ADDENDUM NO. 2

May 6, 2022

NEW ADMINISTRATION CENTER, ALTERNATE EDUCATION AND RESOURCE CENTER AND RELATED WORK PROJECT
Crown Point, IN 46307

ADDENDUM TWO

SHEET AR P-110

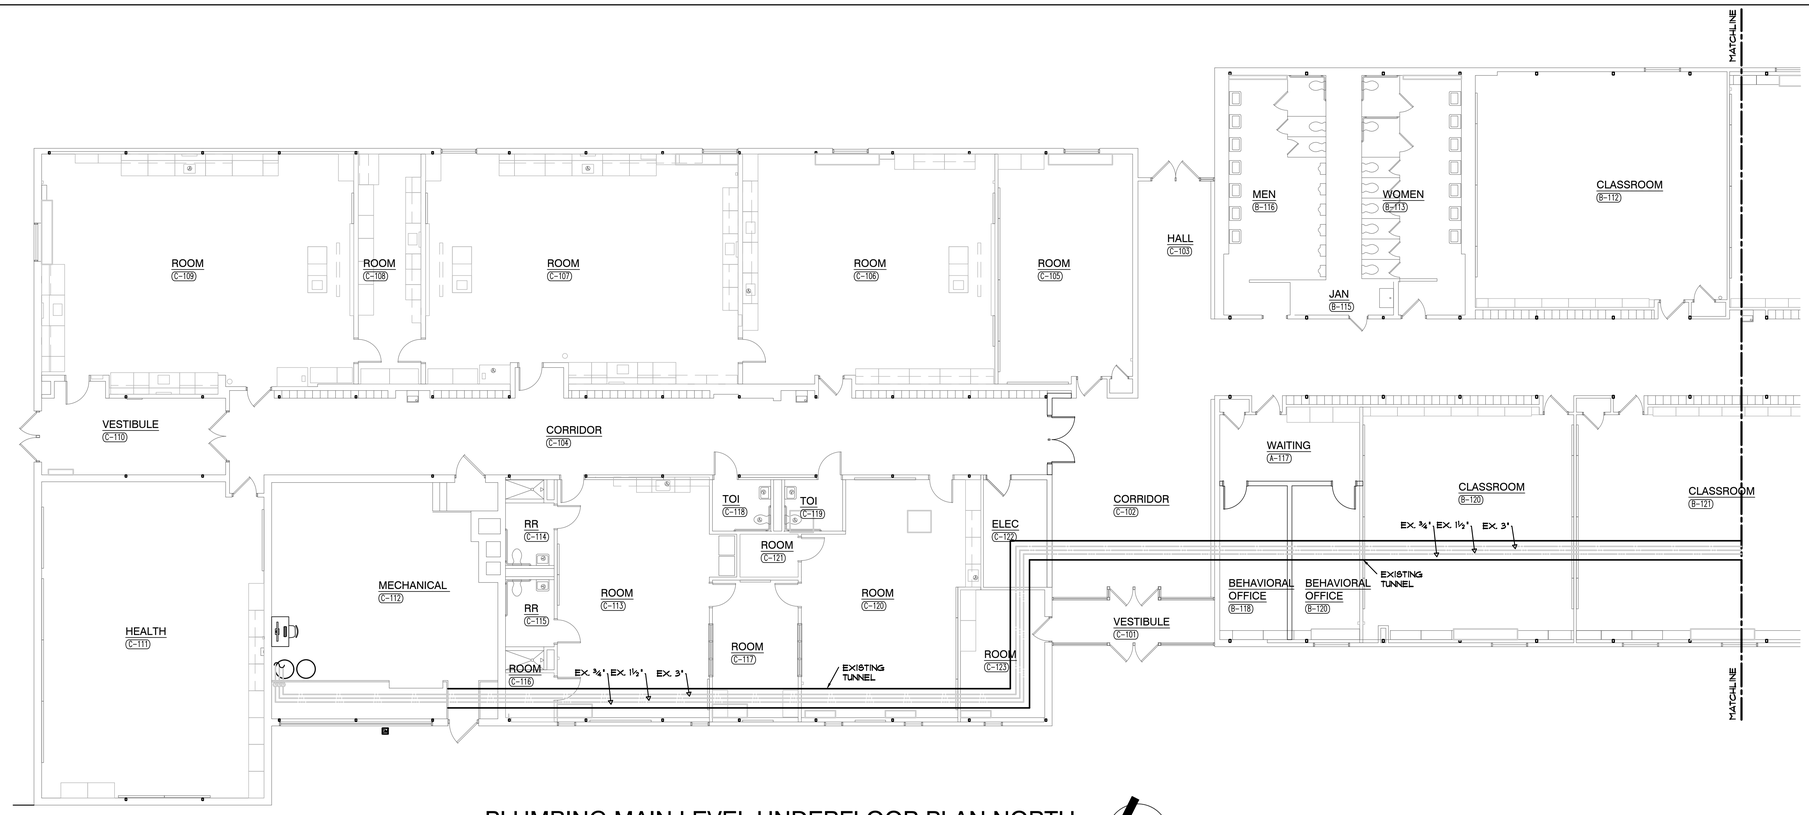
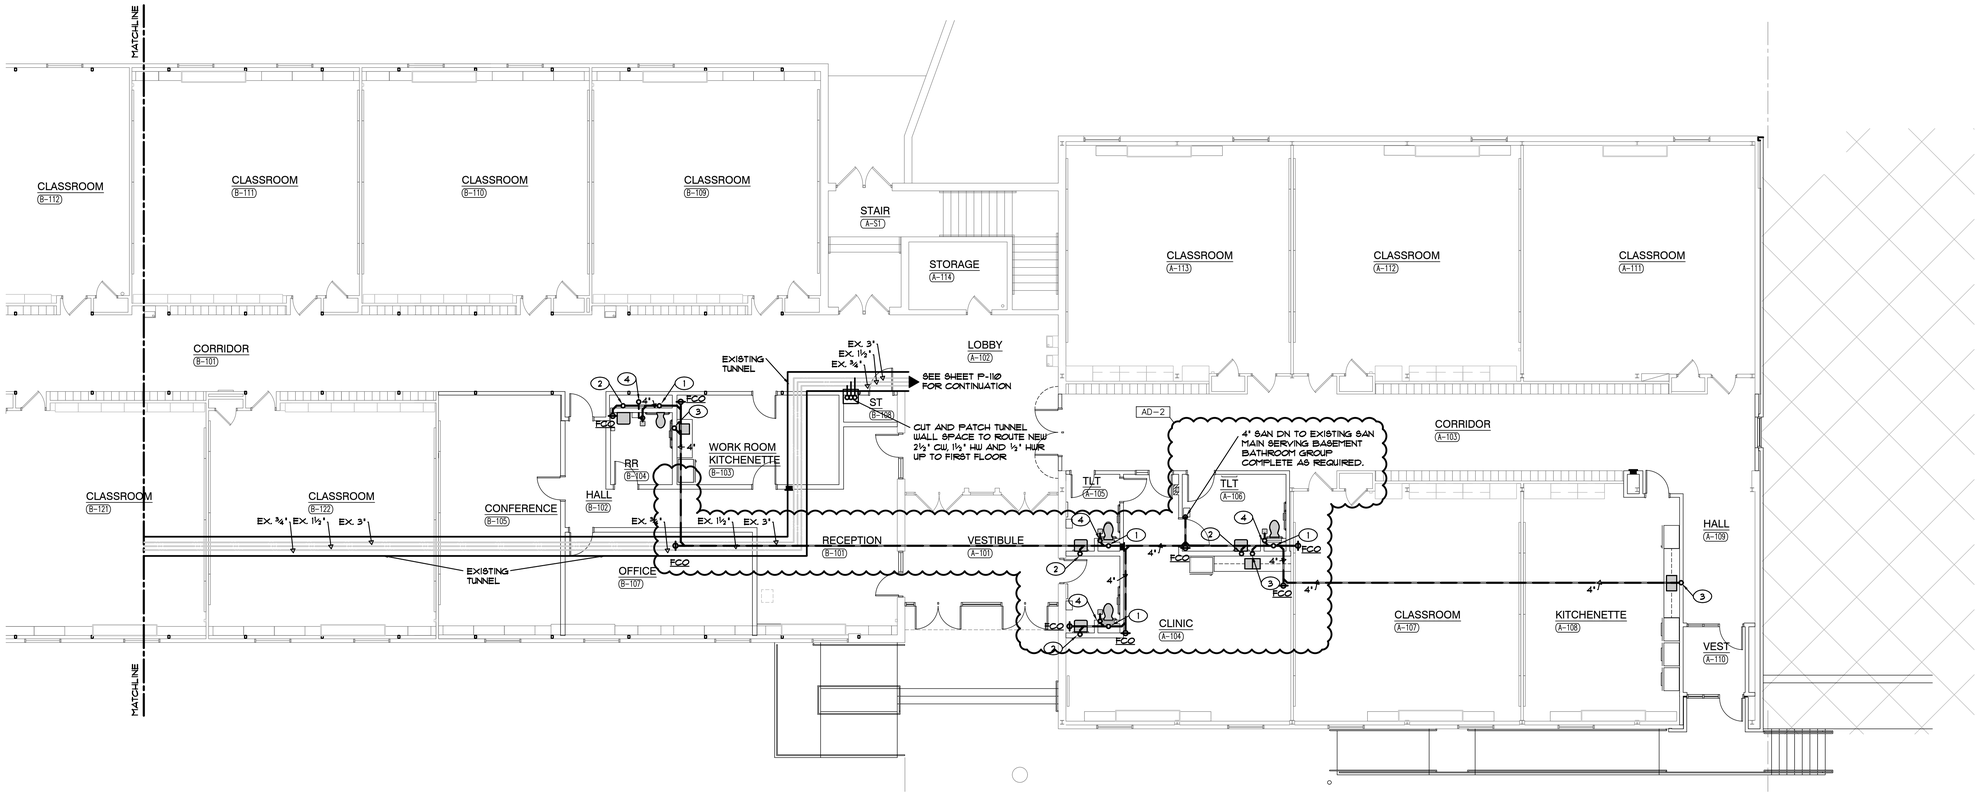
1. Revised domestic water piping to be located in basement ceiling space.
2. Revised sanitary piping.

PLUMBING MAIN LEVEL FLOOR PLAN NORTH

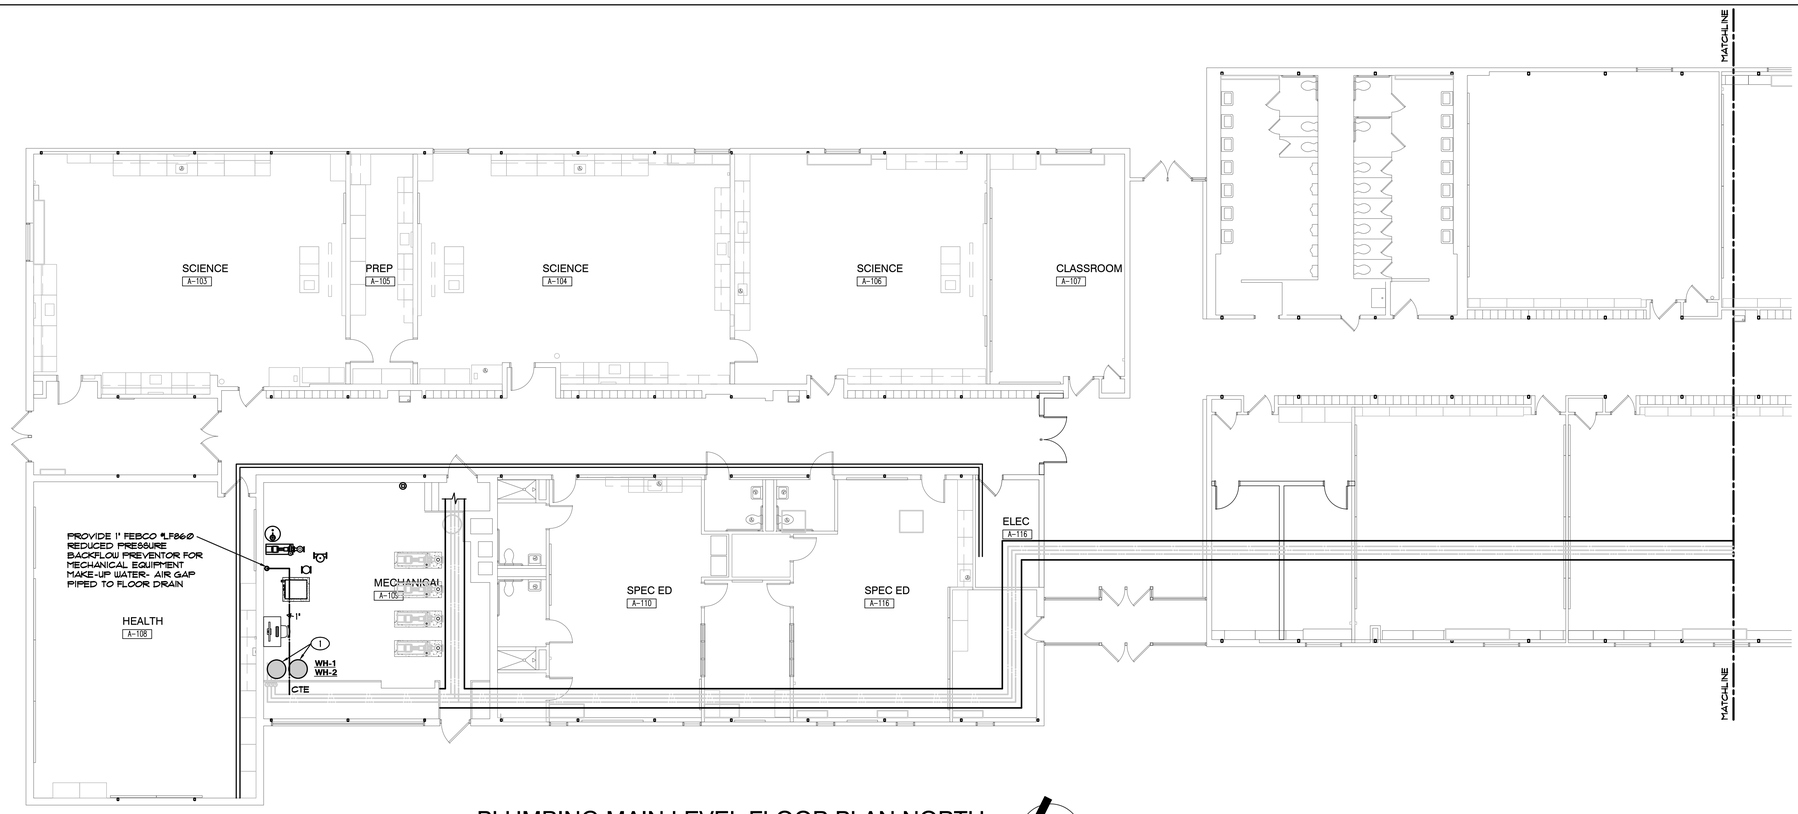
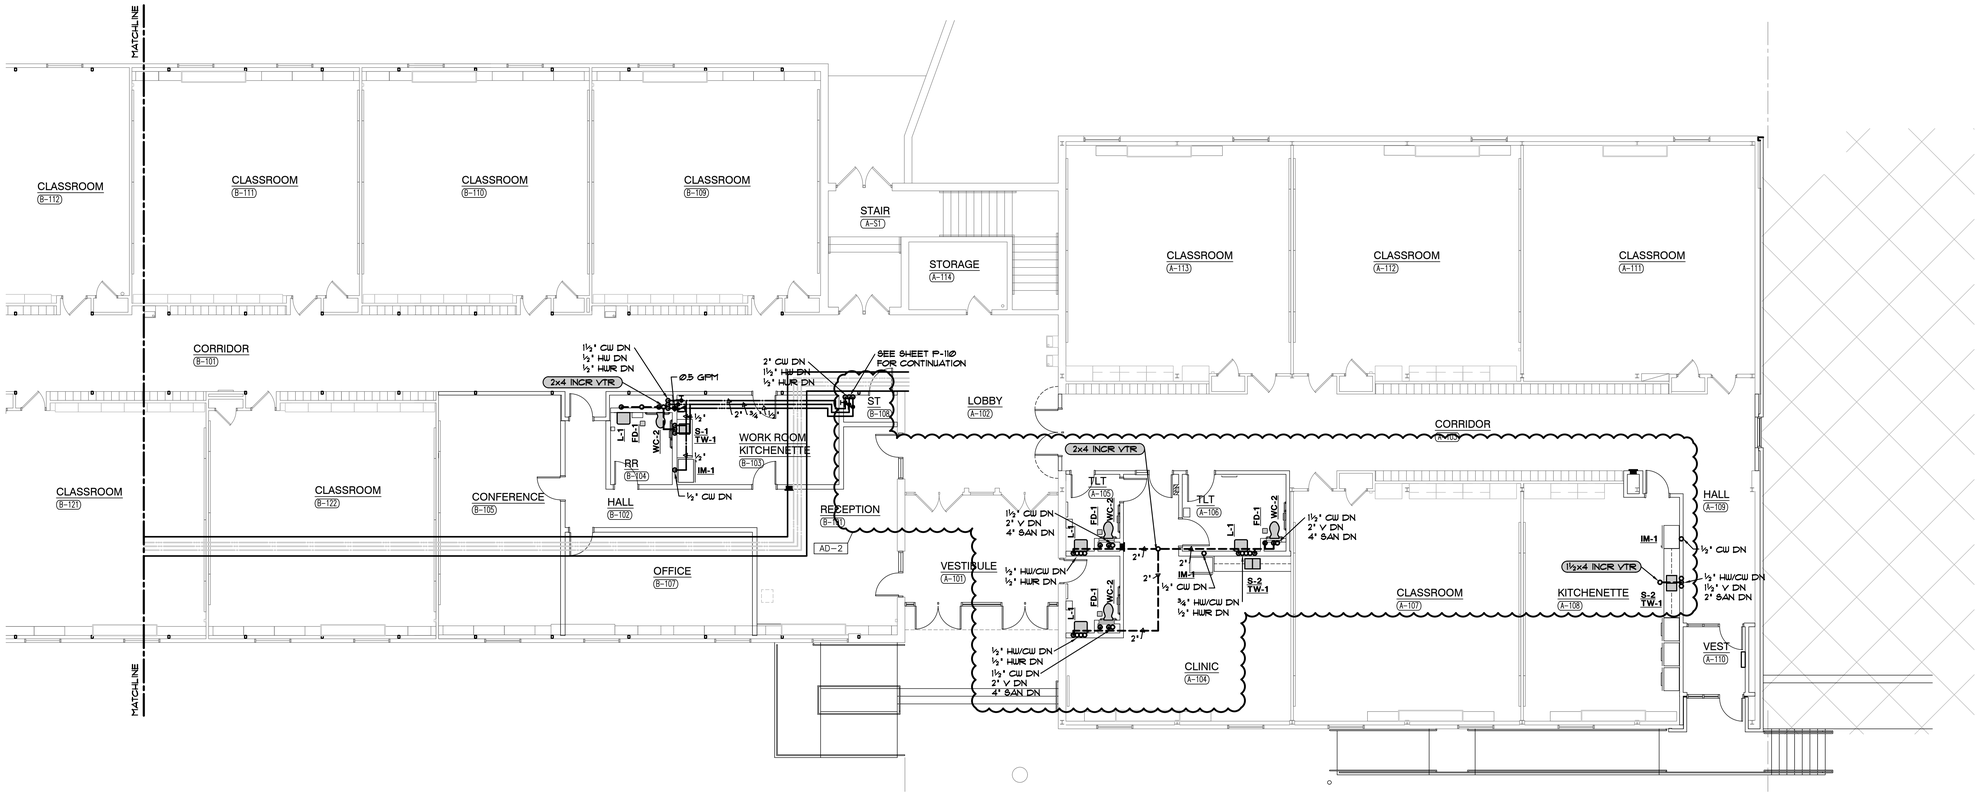
1. Revised sanitary piping.
2. Added single-use toilet Room A-101A.

1 EP102 **SECOND FLOOR ELECTRICAL POWER PLAN**
1/8" = 1'-0"

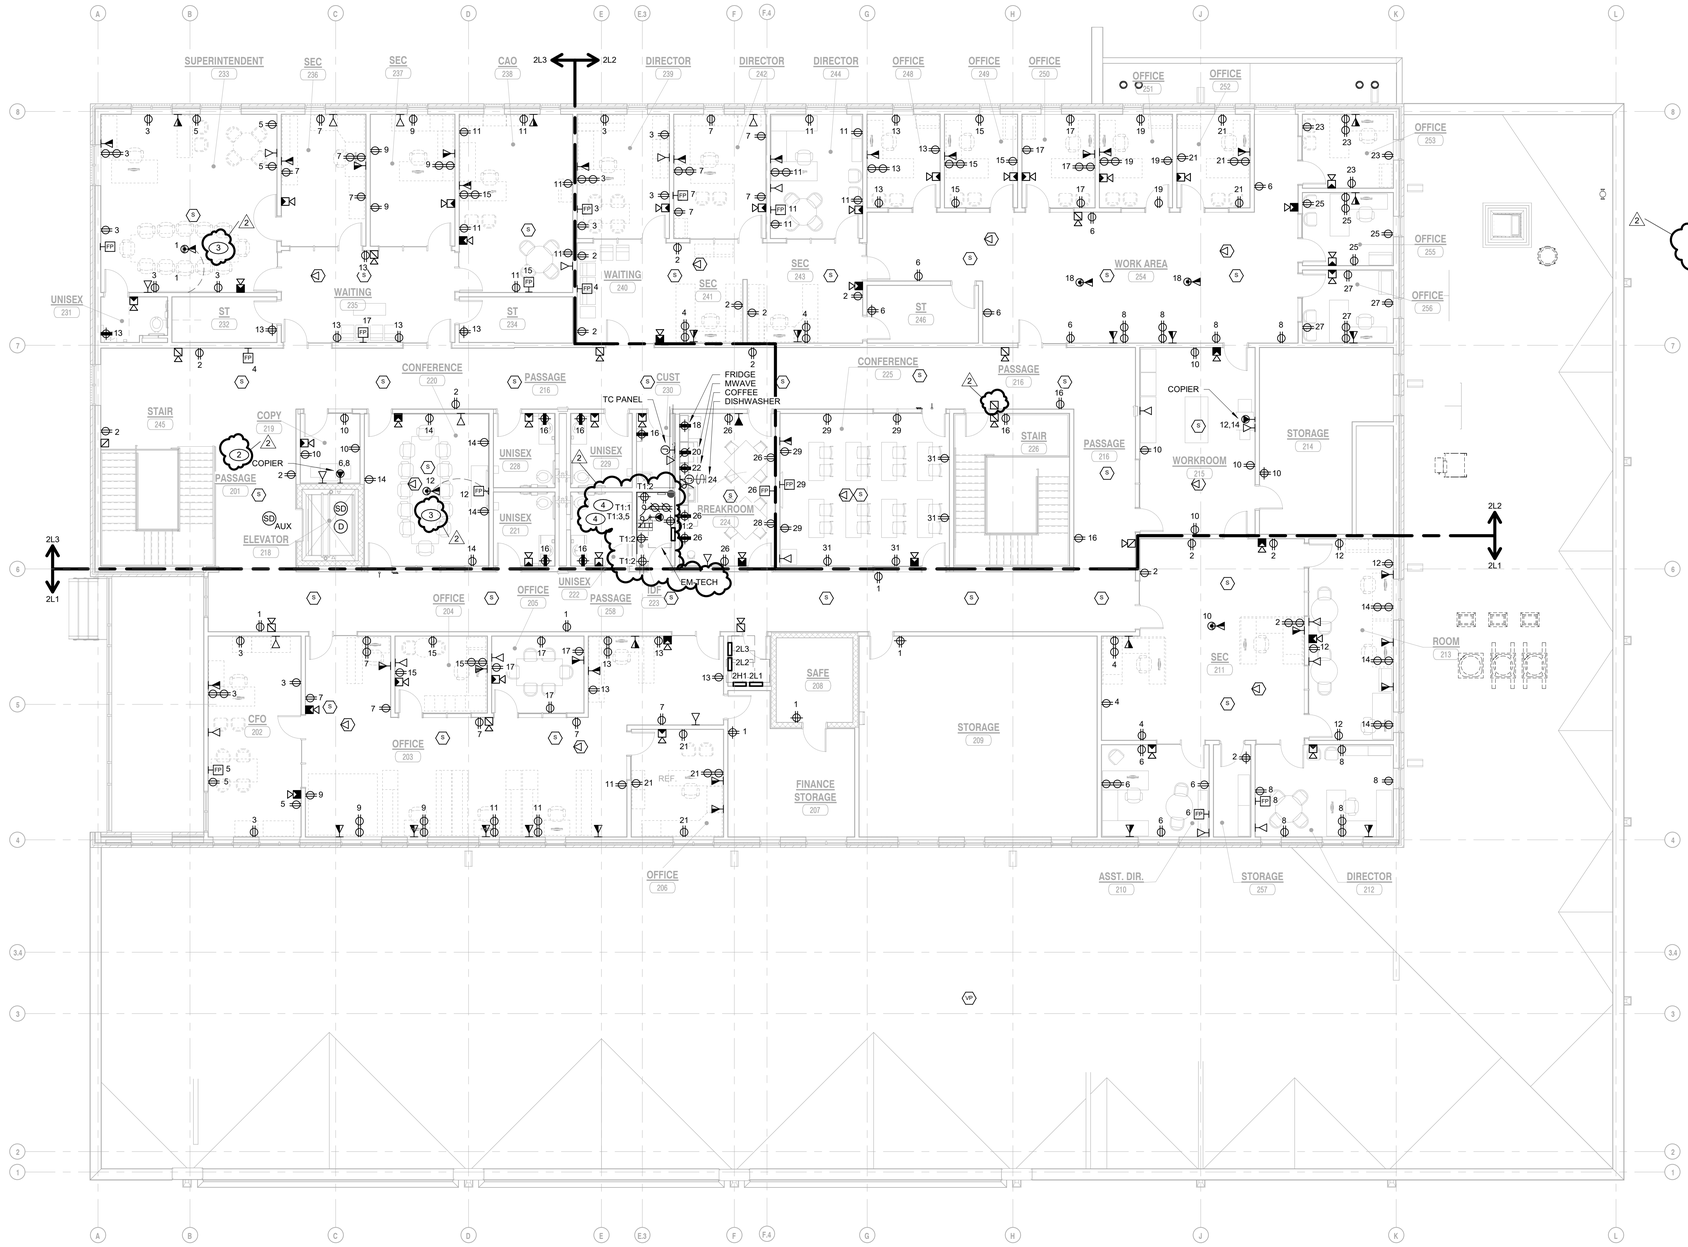
A. Refer to revised full size drawing, included in this Addendum, for the following revisions:
   1. Added flat panels.
   2. Added sheet notes.
   3. Added cooler and freezer condensing units.
   4. Removed floor boxes.
